## County of Fairfax, Virginia

### **STAFF REPORT**

**APPLICATIONS RZ/FDP 2011-LE-016**  
**Waiver #5490-WPFM-002-1**

**PROPOSAL:** Rezone the 3.38 acres site for the development of a  
multi-family residential building for 245 dwelling units,  
including affordable units.

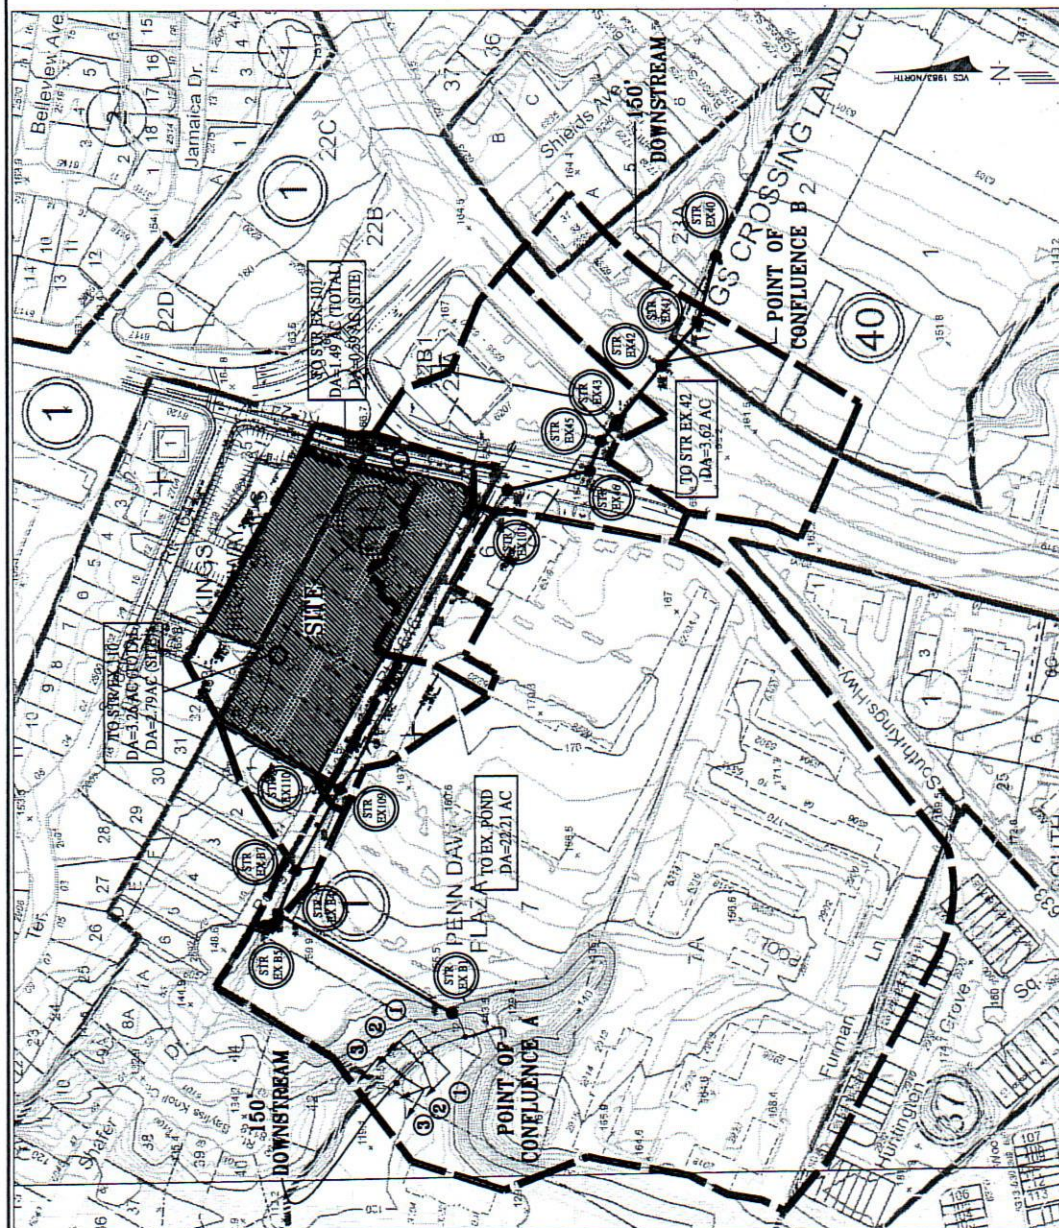
An outfall narrative has been provided, however, the extent of review does not meet the submittal requirements of 100 times the site area (ZO 18-202 paragraph 10.F(2)(c)). The site area upstream of Str 35 seems to be left out of the outfall calculations on Sheet 7.
